**RESPONSE TO ENVIRONMENTAL PROTECTION
AGENCY'S DRAFT NPDES PERMIT**

**PSNH MERRIMACK STATION
UNITS 1 & 2
BOW, NEW HAMPSHIRE**

**Prepared for
Public Service Company of New Hampshire**

**Enercon Services, Inc.
500 TownPark Lane, Suite 275
Kennesaw, GA 30144**

Figure 1: Spacing Criteria for Johnson CWW Screens [Ref. 6.19]

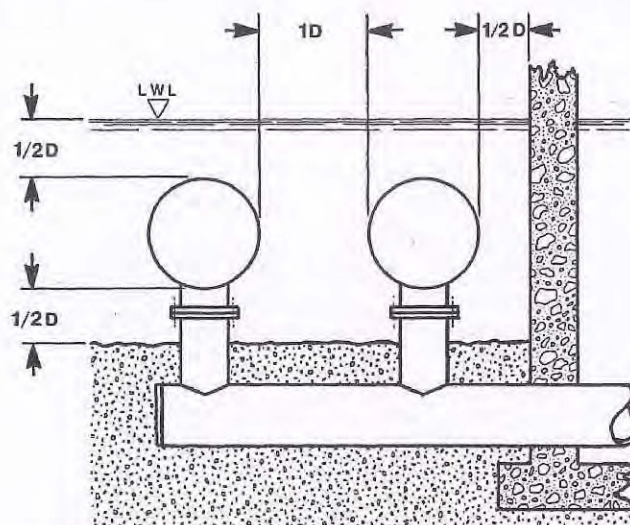
In the draft permit, EPA also concludes that the Merrimack River is too shallow for CWW screens. The 2009 Report [Ref. 6.2] indicated that a CWW screen diameter of 24 inches was chosen for the design of Merrimack Station to take into account the mean low water level of 4 ft. Correspondence with Johnson Screens, the leading CWW screen manufacturer, indicates that one half diameter of clearance must be provided above and below the outer edge of the screen [Ref. 6.2]. The Product Application Guide from Johnson Screens [Ref. 6.19] also gives this spacing requirement, shown in Figure 1. For a 24-inch diameter screen, this signifies a requirement of one foot of water above the top of the screen, and one foot of water between the bottom of the screen and the bottom of the river. Therefore, 24-inch diameter CWW screens can be designed to operate in as little as 4 ft of water.

The 2009 Report presented a preliminary layout of CWW screens. This preliminary layout showed CWW screens being installed from approximately 60 ft to approximately 95 ft offshore in front of the existing Unit 1 and 2 screen houses [Ref. 6.2]. As discussed in the 2009 Report, the mean low water level in the vicinity of the CWW screens is 4 to 6 ft, with an average depth of 6 to 10 ft. Crude bathymetry data provided by Normandeau for the lower Hooksett Pool demonstrated water depths of approximately 7-15 ft along this transect in the region closest to where the CWW screens would be installed (Attachment 1, Section 2). This data is obtained from the N-5 transect, located just south of the intake structure [Ref. 6.11]. More detailed bathymetry data would be necessary to confirm the depths of the river in this area, but currently available data suggests that water depth would not be an issue for a 24-inch diameter CWW screen installation.

Figure 3: Existing Open-Cycle Cooling Flows at Merrimack Station

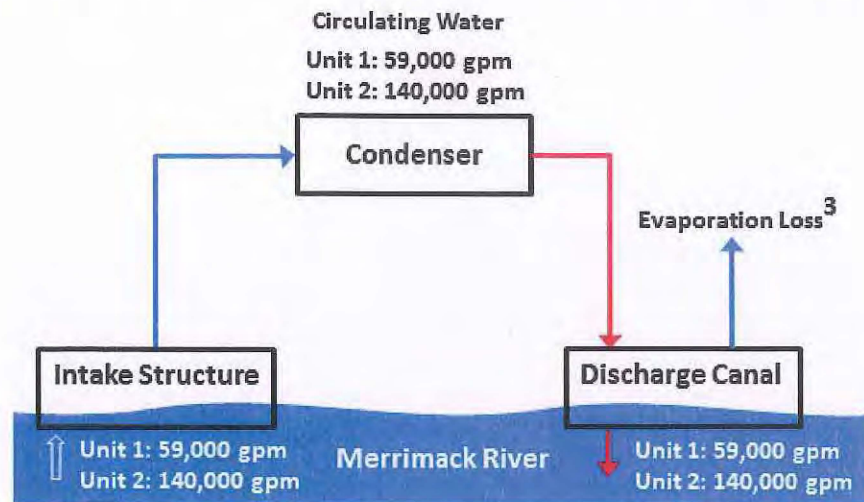
In the draft permit, EPA states that the PSNH estimation of the impact of additional evaporation upon the Merrimack River errs on the high side because it does not take into account evaporation already occurring in the existing cooling system. Although this statement is technically correct (the evaporation resulting from operation of the current system was not included in the estimation), the current cooling system evaporates only a very small amount of water, especially when compared to the evaporation that would occur using a wet or hybrid cooling tower. Unlike cooling towers, the primary mechanism by which the PSMs cool water is convection, and not evaporation. Additionally, the existing

Simplified schematics of the closed-loop and open-loop cooling water system configurations are shown in the Figures below; Figure 3 depicts the existing open-cycle configuration, while Figure 4 shows a potential closed-cycle configuration. It is estimated that the closed-cycle cooling system would consume approximately 3,325 gpm of water. This amount of water loss is equivalent to approximately 2,640 Olympic-sized swimming pools per year [Ref. 6.21]. Note that several smaller miscellaneous loads (e.g., slag sluice, de-icing recirculation, travelling screen wash, equipment cooling, fire water, etc.) are not included in the schematic diagrams below for simplicity.

It is important to note that while a closed-cycle cooling system draws significantly less water from the river than an open-cycle cooling system, it consumes significantly more
